Assessment of Pacific Gas & Electric Company's Pipeline Safety Enhancement Plan

**Prepared For
Consumer Protection & Safety Division**

December 23, 2011

For Jacobs Consultancy,

Figure 5 - PG&E Program Management Organization Structure

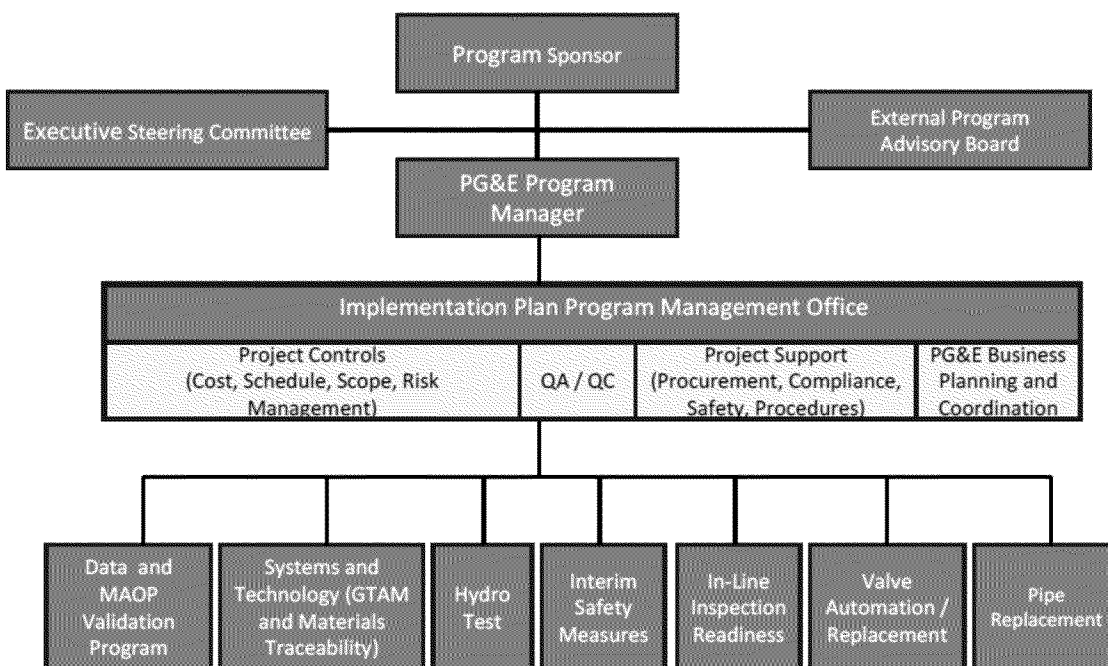
While the specific structure of a program management organization can somewhat vary based on a given program's size, complexity, and client needs, the PG&E program management organization structure, as shown in Figure 2, is consistent with industry practices, as are the roles and responsibilities of the major functions. The major functions of PG&E's programs management organization are:

- The Implementation Plan PMO organizational structure looks to provide a good framework. The organization and governance is based on current industry practices.
